Product Change Notification: E-21-005720

**General Product Description:**  
AMPMODU MTE HEADER ASSEMBLIES

# MTE SHROUDED HEADER HOUSING TOOLING CHANGE

Product Change Notification: E-20-000624

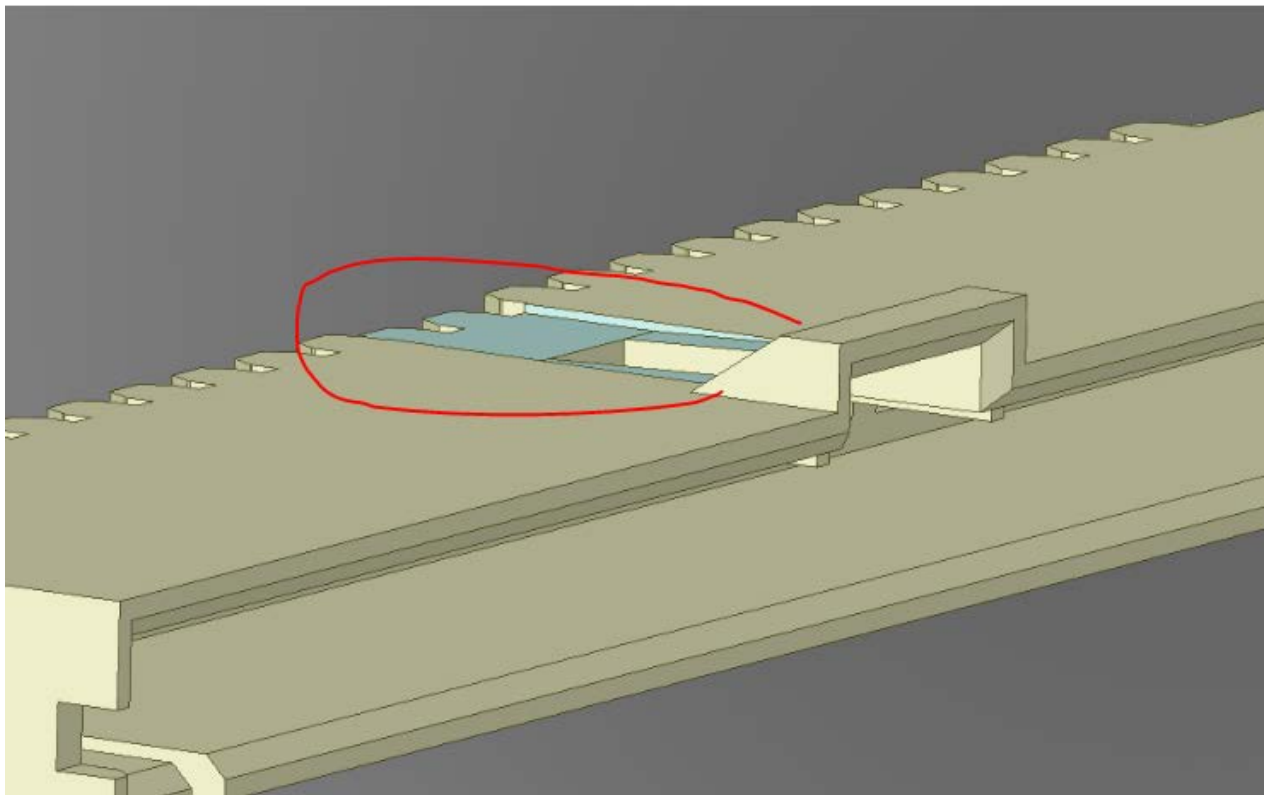
**Description of Changes**  
ADDENDUM TO PCN E-20-000624 (ATTACHED). ONE OF THE CHANGES NOTED IN PCN E-20-000624 IS NOT BEING IMPLEMENTED DUE TO FINANCIAL IMPLICATIONS. THE TOOLING CHANGE SHOWN IN THE ATTACHED MTE SHROUDED HEADER TOOLING CHANGE FILE IS BEING MADE TO BE AT THE MOLDER'S DISCRETION. SOME PARTS MAY HAVE THIS RECESSED AREA, SOME MIGHT NOT. THERE IS NO PERFORMANCE DIFFERENCE BETWEEN THE PARTS WITH THE RECESSION AND THE PARTS WITHOUT THE RECESSION.  
**Other attachments:**  
[MTE Shrouded header tooling change](#)  
[PCN E-20-000624](#)

To provide flexibility to our manufacturing processes, we are allowing the manufacturing plants, when possible, to utilize regrind resin, up to the allowable limit specified on the UL Yellow Card, in the molding process. Adding feature at latch to increase mold efficiency.

## CURRENT HOUSING BEFORE CHANGE

## HOUSING AFTER CHANGE
